Response to Submissions

Central Courtyard Precinct
State Significant Development Application

Submitted to Department of Planning and
Environment
On behalf of Macquarie University

10 October 2018 | 17336

Figure 1 Comparison of previous and proposed roof design

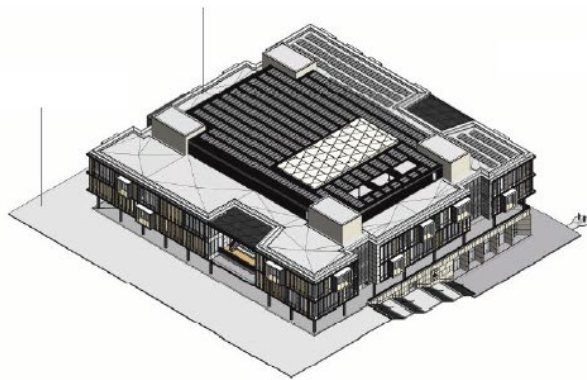
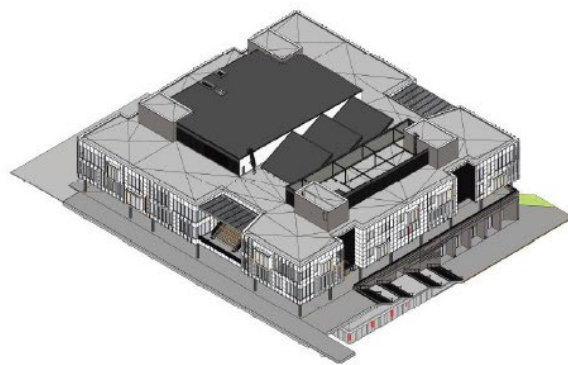
- The public domain surrounding the MUCCP may be affected due to potential overshadowing and wind impacts.
- The rooftop plant dominates the upper levels of the building and could be further articulated.
- Internal design to maximise solar access and views could be improved.

The roof has been redesigned to reduce any perception of bulk and scale, as demonstrated by **Figure 1**. The revised design emphasises the skylight as a distinct element and the roof plant is set back from the perimeter of the building to reduce its visibility from the surrounding areas.
